5.5'
6.0'
S-64°21'00"-W
MULTI-ENGINE NE-ST CONDO-UNIT "F" 2ND AMENDMENT
THIS DRAWING SHOWS BLDGS MOVING AWAY FROM PROPERTY LINE BUT DIMENSIONS SHOW BOTH UNITS BEING 3.5' OFF LINE!
ARE ALL REFERENCE DIMENSIONS AT RIGHT ANGLES TO PROPERTY LINES? IF THEY ARE, THIS SHOULD BE NOTED.
NEED BETTER TIE-INS TO SET BLDGS.
APPROVED LORAIN CO. MAP DEPT.
DATE 2/20/91
PAGE 9-D 9-D-1
BY T. McKim
19273
10/23/91

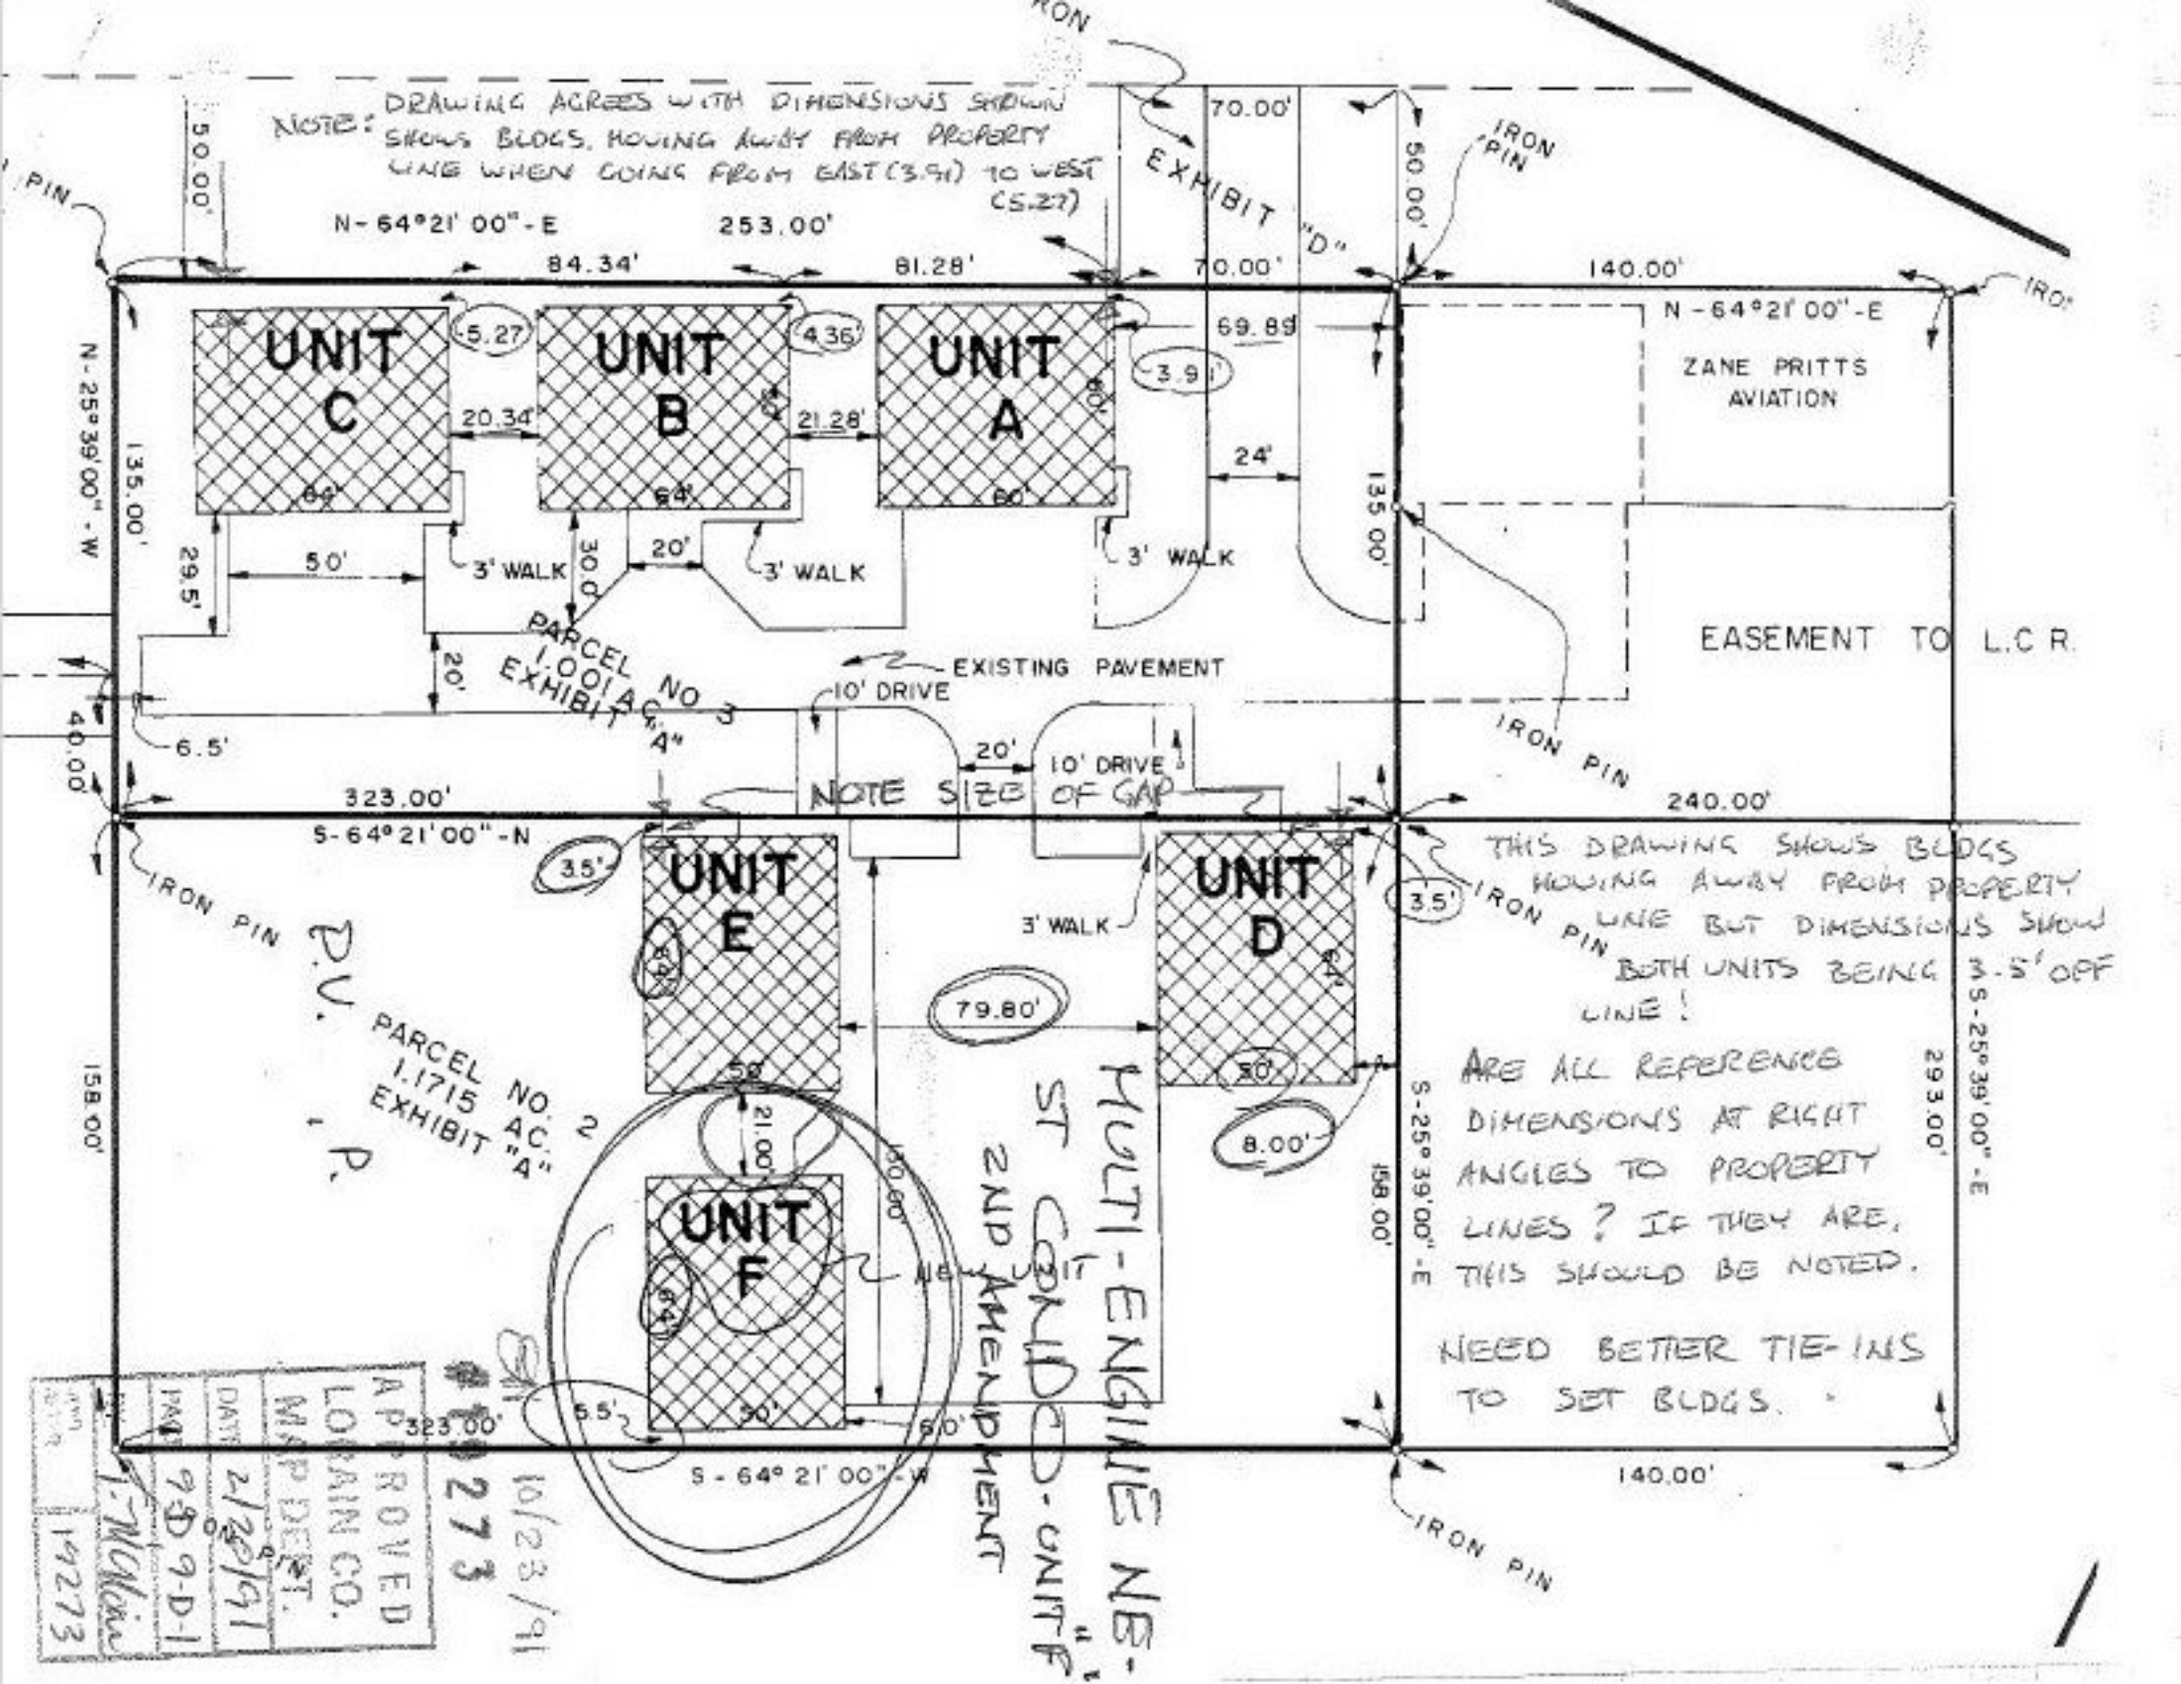
NOTE: DRAWING AGREES WITH DIMENSIONS SHOWN SHOWS BLDGS. MOVING AWAY FROM PROPERTY LINE WHEN GOING FROM EAST (3.91) TO WEST (5.27)
EXHIBIT "D"
IRON PIN
N-64°21'00"-E
